MOTOROLA

Subject: Request for additional information regarding FCC ID: IHDP56JC1

Correspondence Reference Number: IHD81107
Confirmation Number: 811261107
Date of Original Email: December 1, 2008

RF Change 1: Antenna Match Layout Change

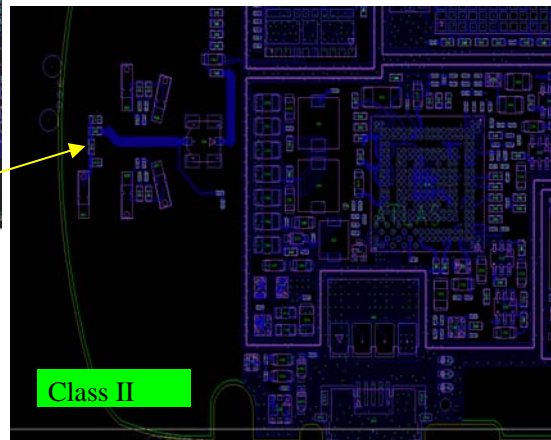
1. Please provide details regarding the changes, photographs, and also justification of why only one frequency band was tested.

- Antenna matching parts were pulled inwards (away from the periphery of the board) to help some issues with ALT drop testing
